REMEDIAL INVESTIGATION/
FEASIBILITY STUDY WORK PLAN
CIRCUITRON CORPORATION SITE
SUFFOLK COUNTY, NEW YORK

revised 4/28/89

REVISIONS TO BE INCLUDED IN THE FINAL WORKPLAN

SUBJECT: EPA CONTRACT NUMBER 68-W8-0110
WORK ASSIGNMENT NUMBER: 004-2LIE
CIRCUITRON CORPORATION SITE
EAST FARMINGDALE, NEW YORK
FINAL RI/FS WORK PLAN

U.S. ENVIRONMENTAL PROTECTION AGENCY
CIRCUITRON CORPORATION SITE
FIGURE 8-1 PROPOSED MONITORING WELL LOCATIONS
EBASCO SERVICES INCORPORATED

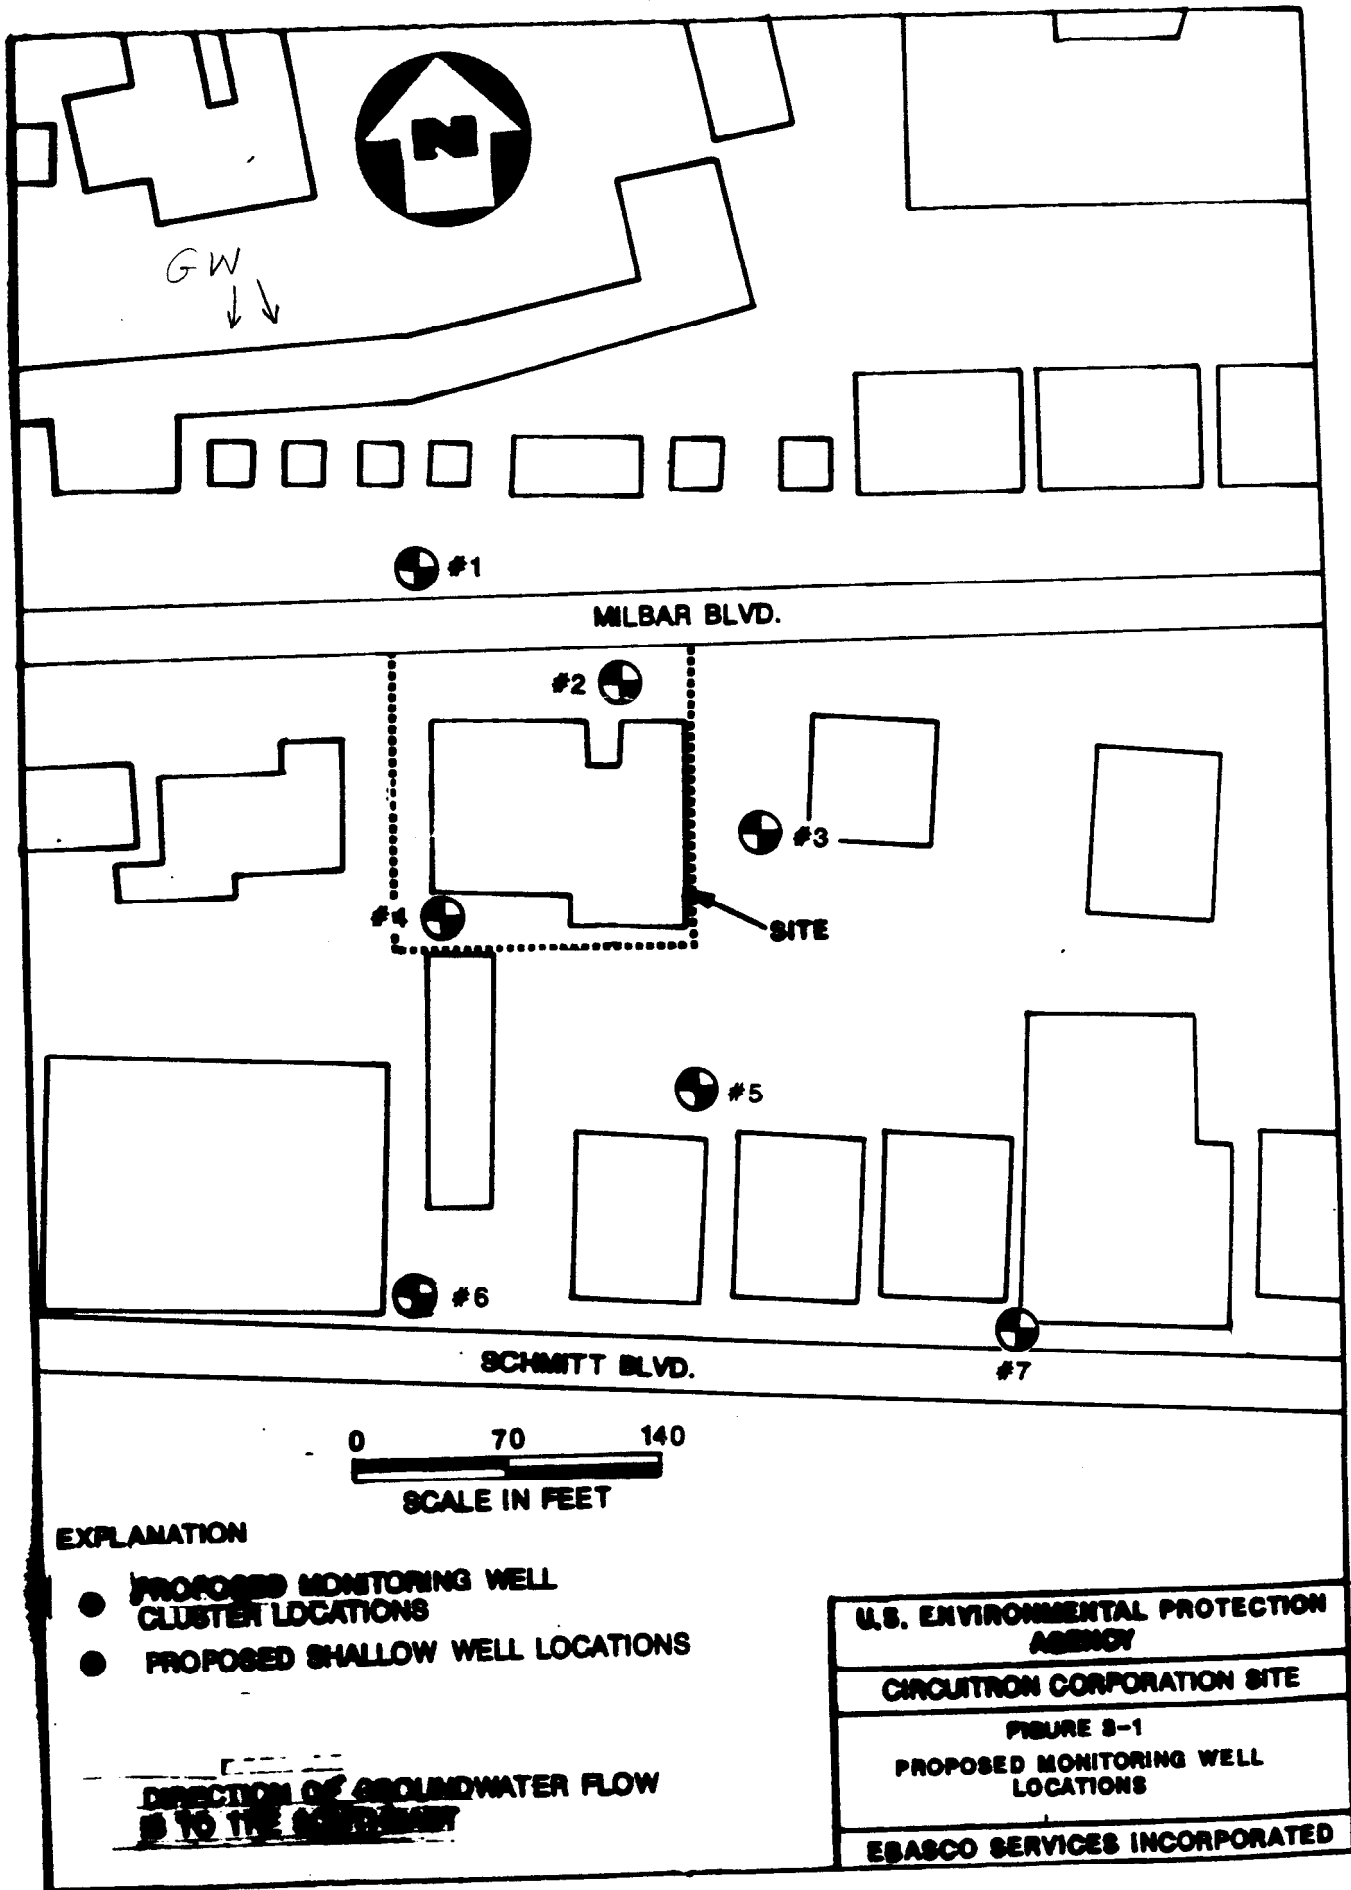
9. Section 3.3.4, page 58, last paragraph, 1st line: Revise the beginning of the sentence to read:
"The seven well clusters will allow...".
10. Figure 3-1, page 59: Figure 3-1 has been revised to show the final locations of the proposed monitoring well clusters.

~~Six (6)~~ ^{Seven (7)} monitoring well clusters ~~and one shallow well~~ will be installed at the Circuitron Corporation Site, as indicated on Figure 3-1. The groundwater program is designed to characterize and delineate possible contaminant transport, both vertically and horizontally, and to determine upgradient water quality parameters. Groundwater elevations will also be recorded in the wells. Data obtained from this program will also be used to model aquifer parameters such as groundwater flow direction and permeability of subsurface stratigraphic units. The cluster locations were selected to provide one cluster upgradient (for background sampling), one cluster between the leaching pools (to act as a point source), and ~~four clusters plus a shallow well~~ downgradient to identify possible contaminant plume movement offsite. ^{five}

U.S. ENVIRONMENTAL PROTECTION AGENCY
CIRCUITRON CORPORATION SITE
FIGURE 8-4
PROPOSED PIEZOMETERS/MONITORING AND PUMP TEST WELL LOCATIONS
EBASCO SERVICES INCORPORATED

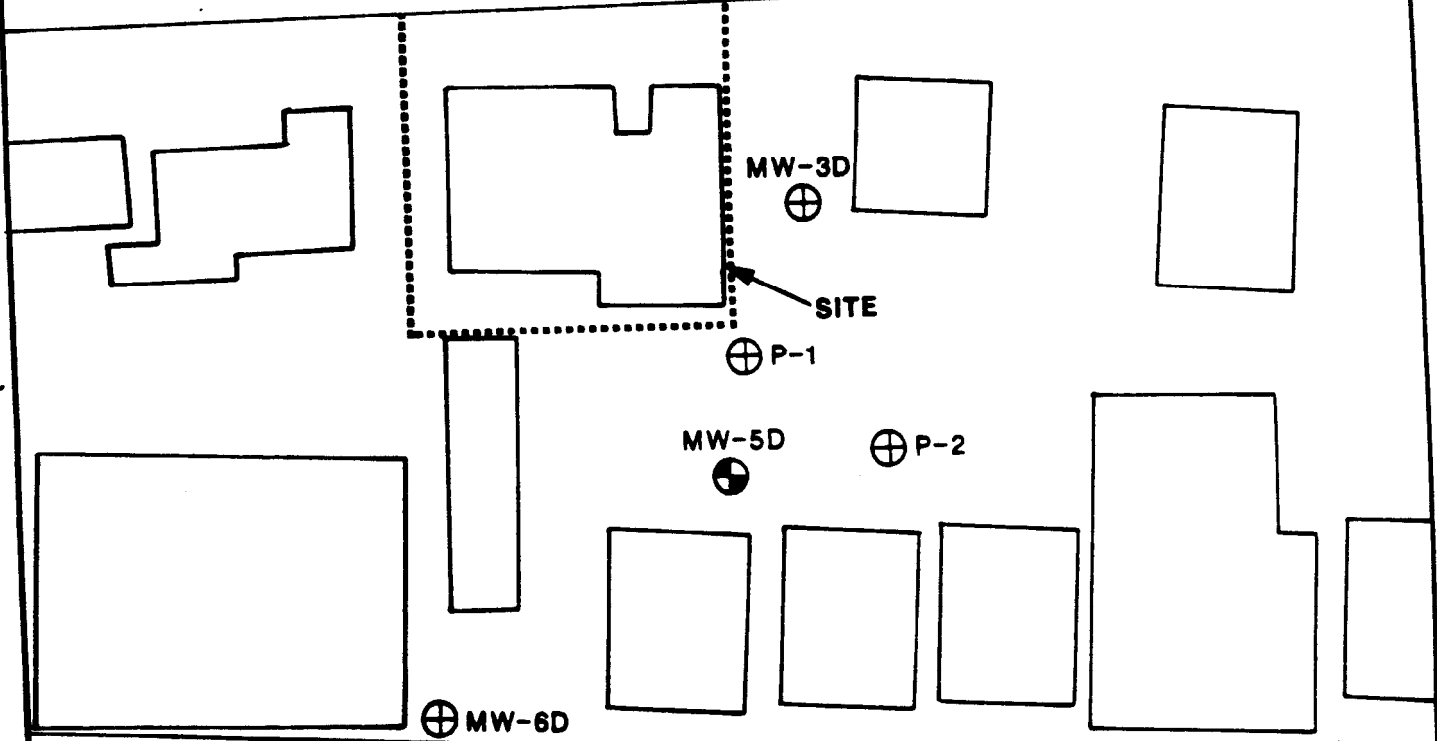
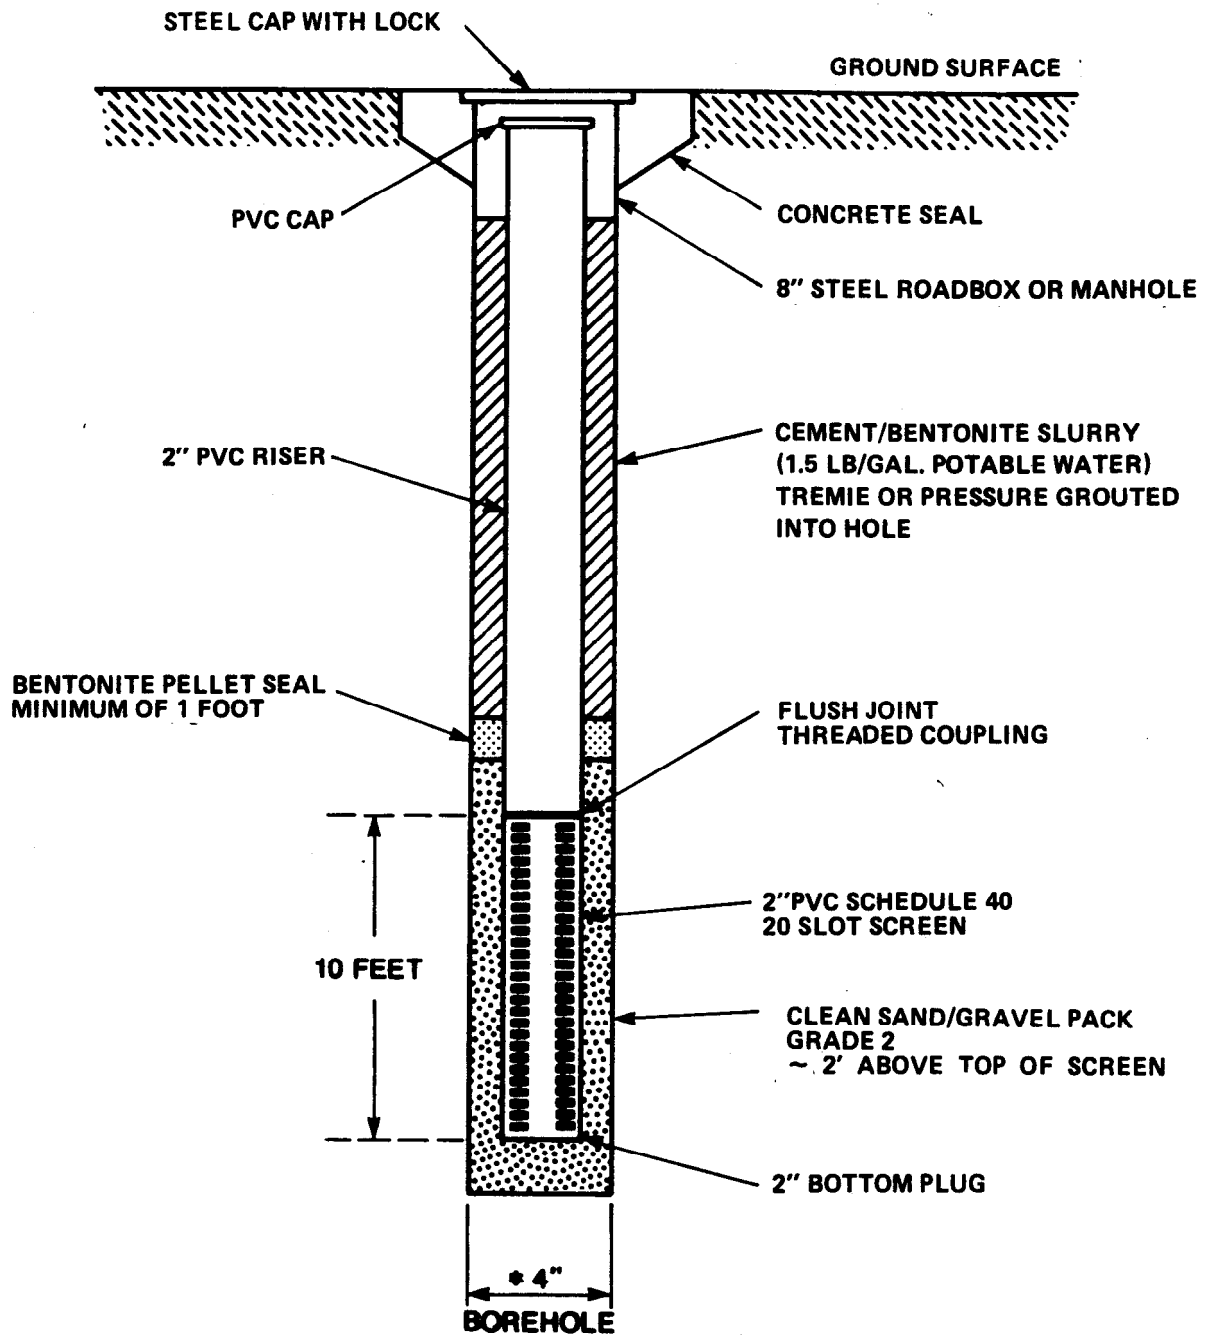
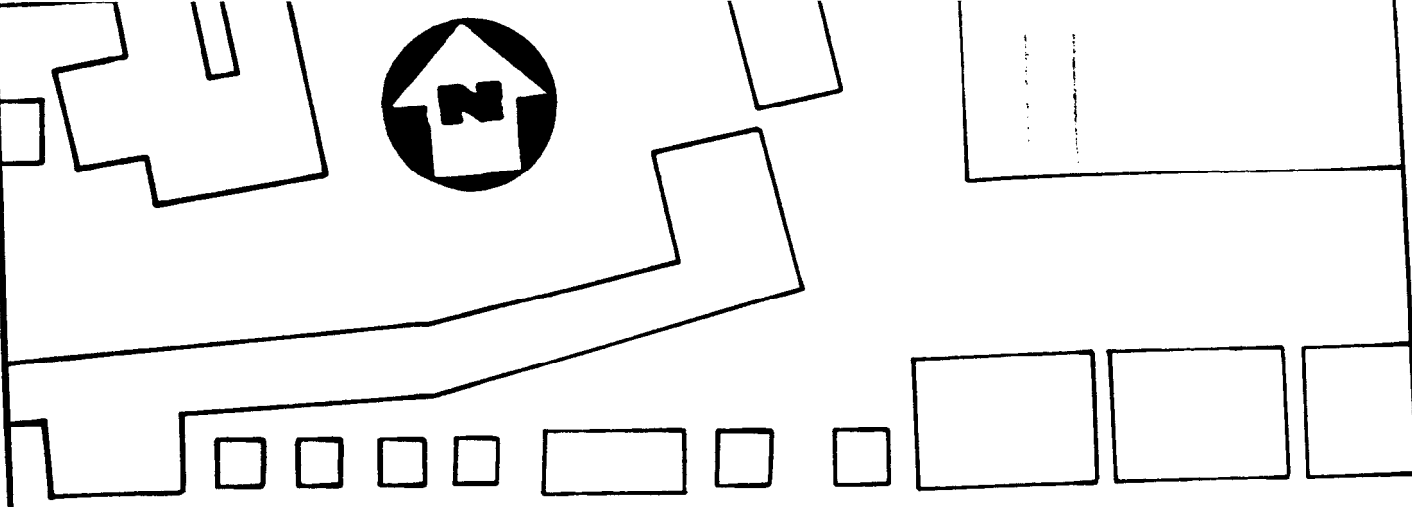
14. Figure 3-4, page 66: Figure 3-4 has been revised to show the final locations of the monitoring wells and the piezometers needed for the optional pumping test.

The pumping test will require the use of four monitoring wells (MW-1D, MW-3D, MW-5D and MW-6D) and two piezometers (P-1 and P-2). The two piezometers (P-1 and P-2) will be installed at the Circuitron Corporation Site at the locations shown in Figure 3-4 and will be used during the aquifer testing for water level recording.
